Notice of Allowability	Application No.	Applicant(s)	
	10/817,367	EGERESI, ZOLTAN	
	Examiner	Art Unit	
	Ralph A. Lewis	3732

Examiner's Amendment

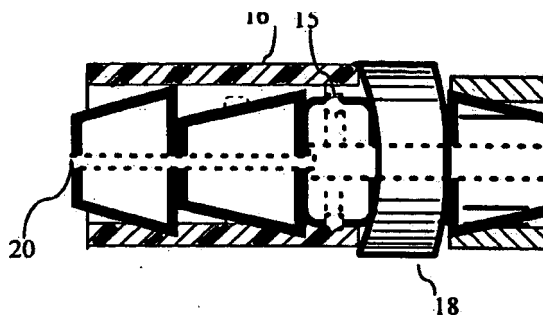
In Figures 4, 5, 6, 7, 8, 9, 13 and 14, the cross section of element 16 is amended to show flexible cross-hatching for example:

Corrected drawings labeled as "replacement drawings" illustrating the above change are required.
